**V2500-A5/D5 PROPULSION SYSTEM SERVICE BULLETIN**

**V2500-ENG-73-0179**

ENGINE FUEL AND CONTROL – FUEL METERING UNIT – INTRODUCTION OF A WOODWARD AIRCRAFT  
ENGINE SYSTEMS (WAES) REVISED STANDARD OF VESPEL BALL

**ENGINE FUEL and CONTROL - FUEL METERING UNIT (FMU) - Replacement of Vespel Balls, P/N 1419-240**

FMU Family Tree - V2527-A5 and V2527E-A5  
Fig.2

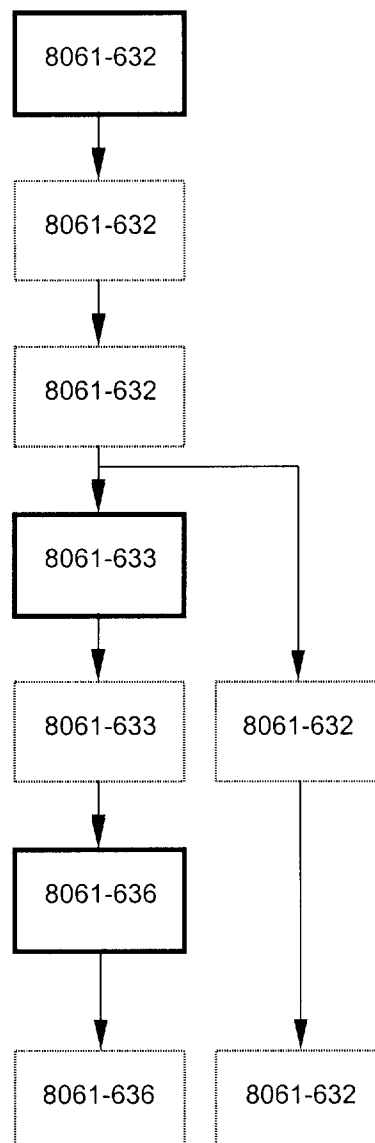
**V2500-ENG-73-0179**

Introduction of a WAES FMU with revised standard of Vespel ball

**ENG-73-0179**

FMU Family Tree - V2527M-A5  
Fig.3

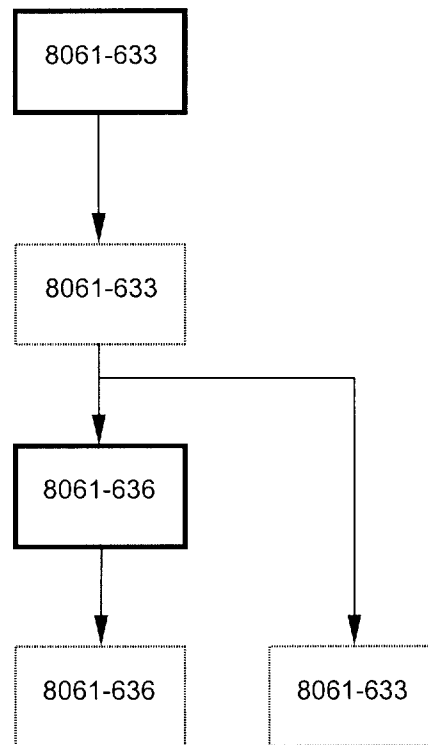
**NONE****V2500-ENG-73-0179**

Introduction of a WAES FMU with revised standard of Vespel ball

**ENG-73-0179**

FMU Family Tree - V2525-D5 and V2528-D5  
Fig.5

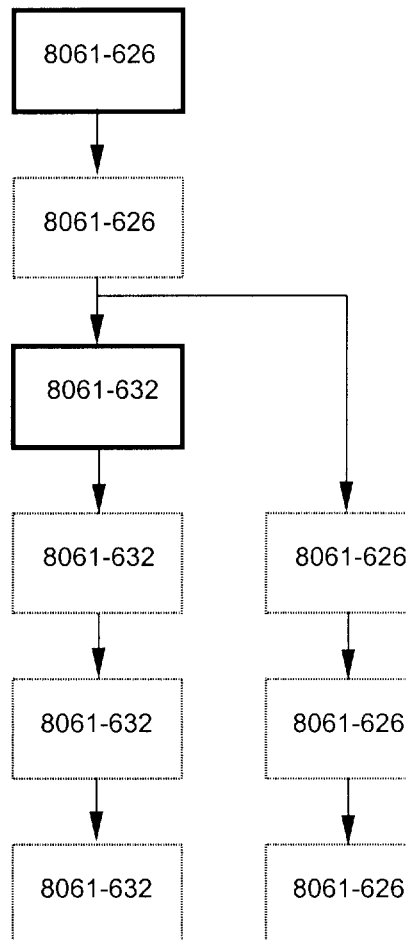
**V2500-ENG-73-0179**

Introduction of a WAES FMU with revised standard of Vespel ball

ENG-73-0179
